**RE: Presidential Cultivation
9910 Acoma Rd SE
Grading and Drainage Plan
Engineer's Stamp Date: 5/12/2022
Hydrology File: L20D076**

Based upon the information provided in your submittal received 5/16/2022, the Grading & Drainage Plan **is not** approved for Grading Permit. The following comments need to be addressed for approval of the above referenced project:

Grading Plan

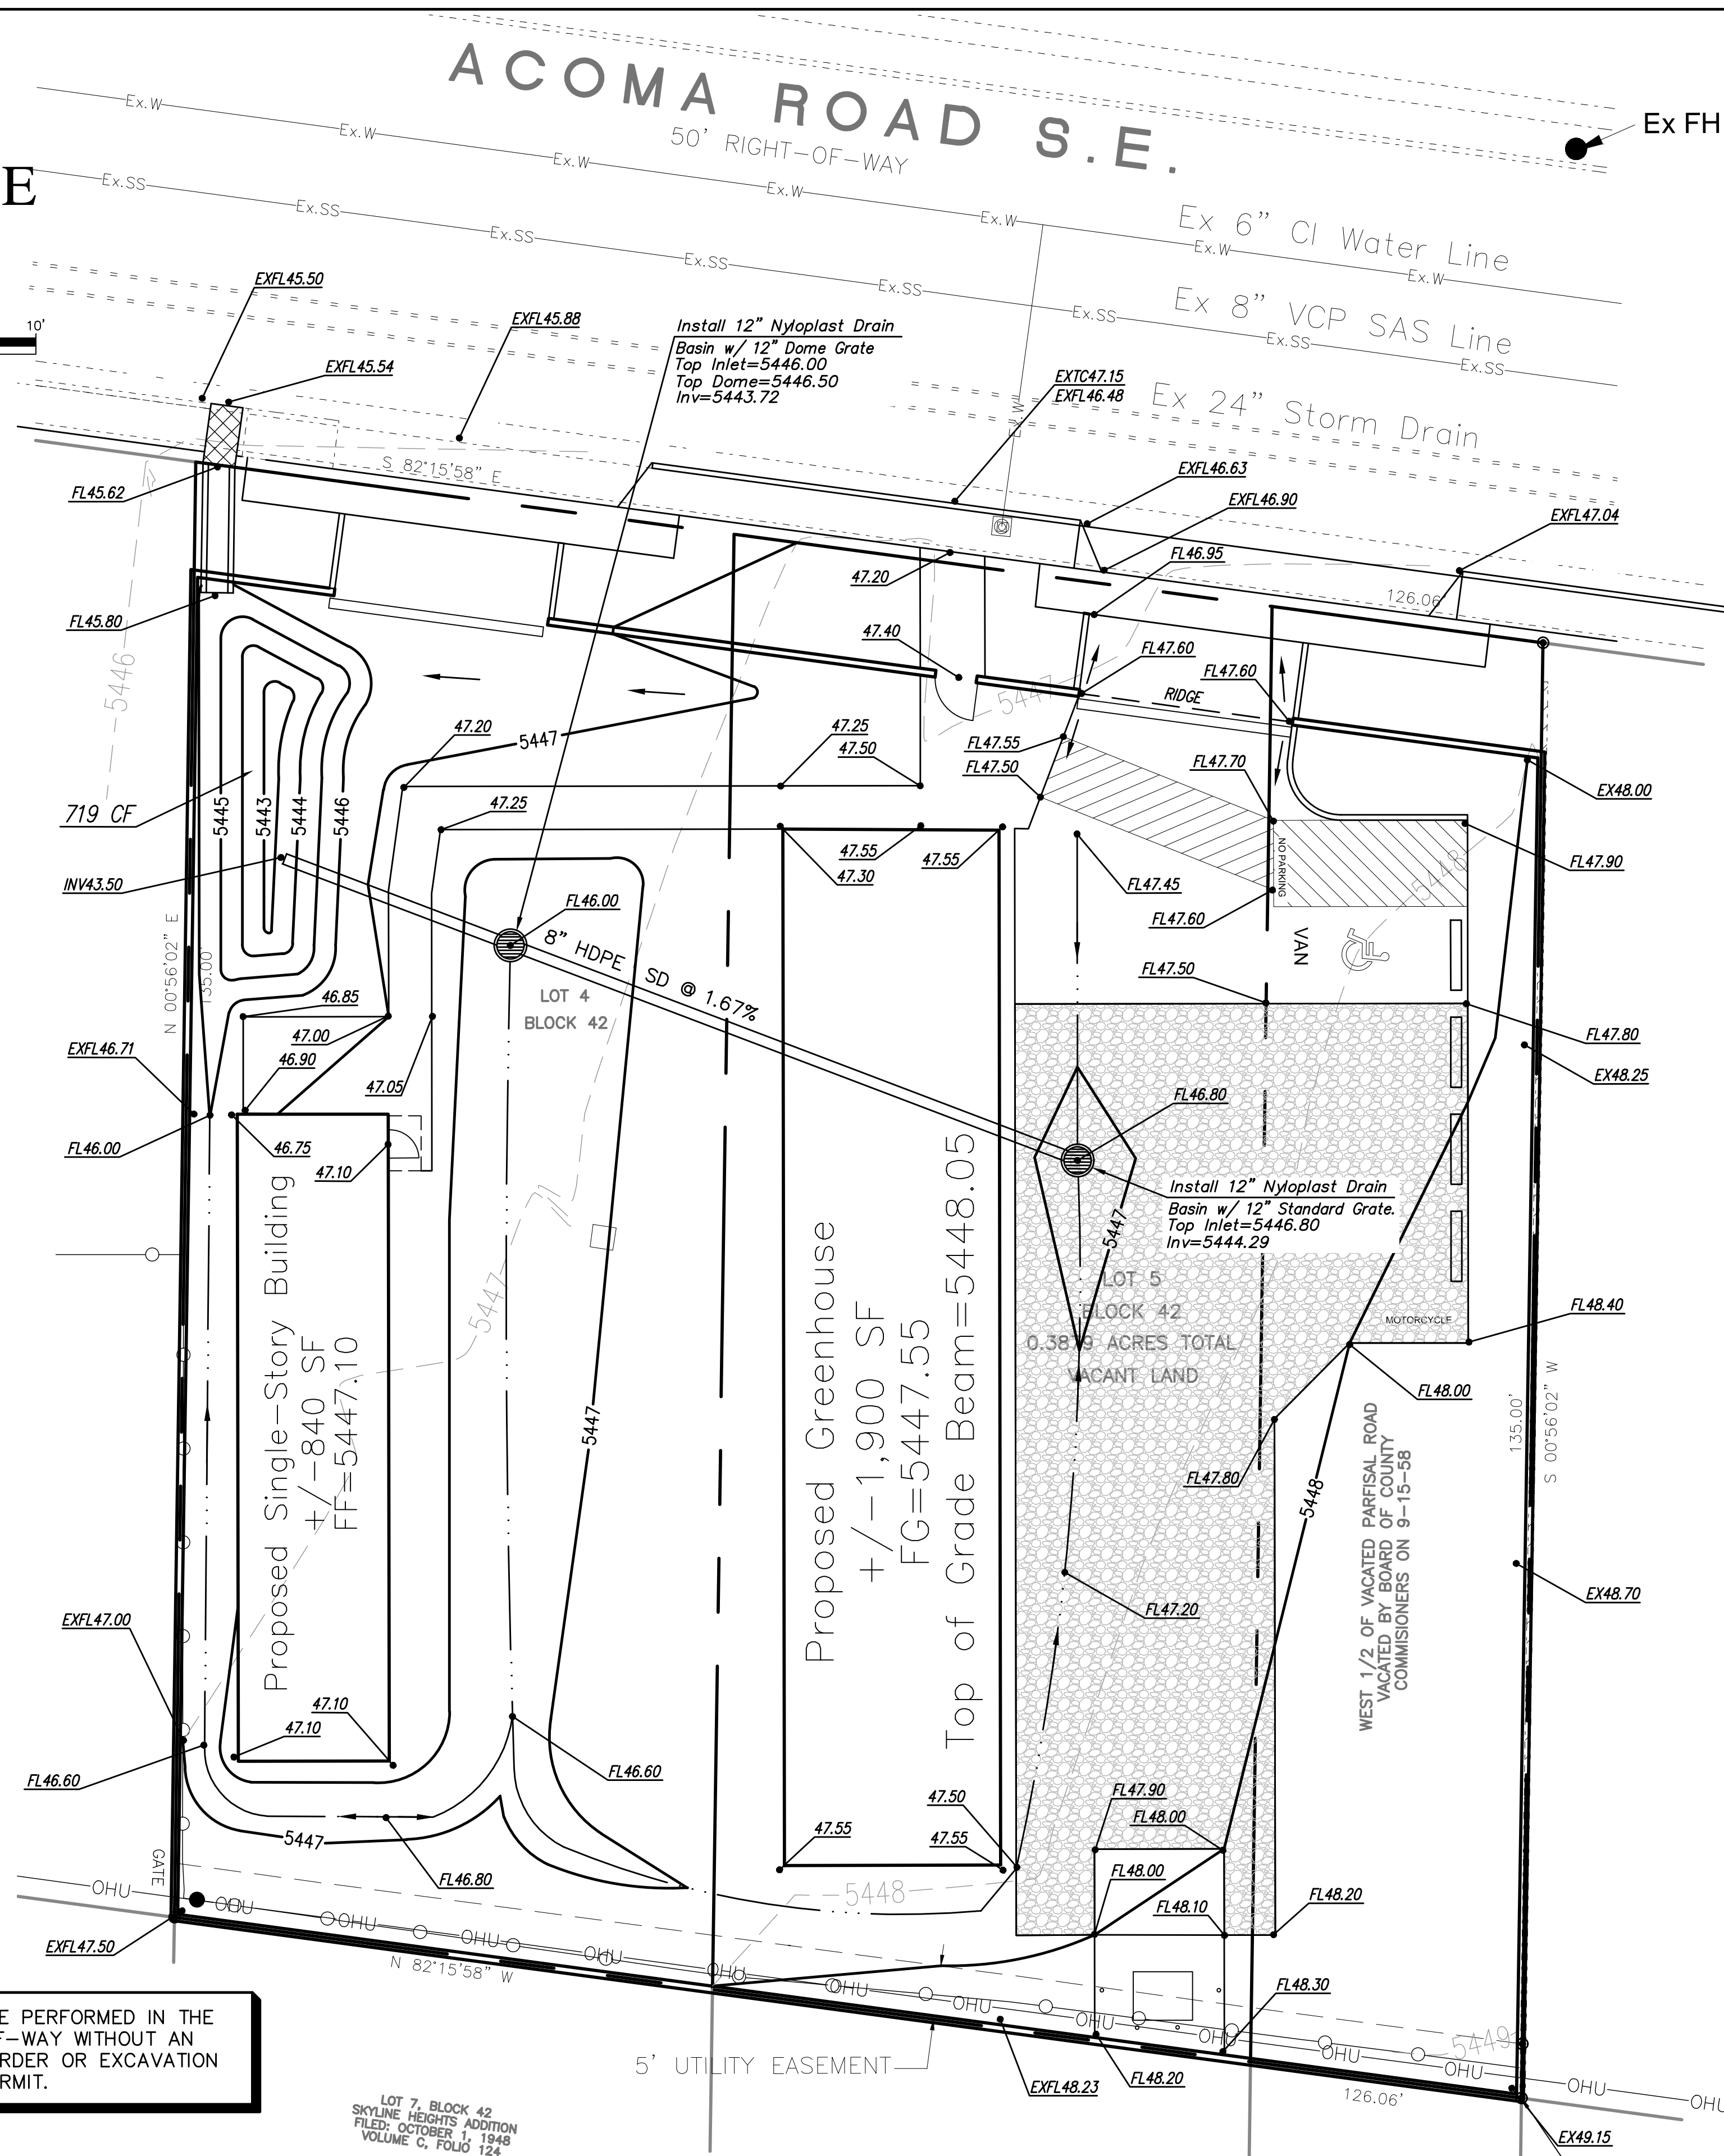
1. Please review calculations for the site.
 - a. Stated in the drainage calculations, the impervious area is 40% of what the total site which is 0.39 acres which is close to 6800 so the SWQV calcs are wrong although the pond is larger anyhow.
2. Provide a cross section of the pond to show water surface elevation, outlet elevation, inlet elevation and SWQV elevation.
3. Are there any proposed walls?
 - a. This is not clear. If so please provide top of wall and bottom of wall elevations.
4. Please provide some adjacent spot elevations to see what your site is tying into.
 - a. It is unclear without information ~10 to 15 ft around subject site.
5. Please include project benchmark and datum.
6. There appears to be a driveway here with a very slim piece of sidewalk between. Can this culvert work here?
 - a. Please review and show adjacent driveway to see how it works out.

- b.
7. Please add a standard commercial entrance per standard detail.
 8. Please provide existing conditions. (calcs etc...)
 9. Please add a note under Grading Notes. "Side slopes need to be stabilized with Native Grass Seed (per City Spec 1012) with Aggregate Mulch or equal (Must satisfy the "Final Stabilization criteria" CGP 2.2.14.b.)".
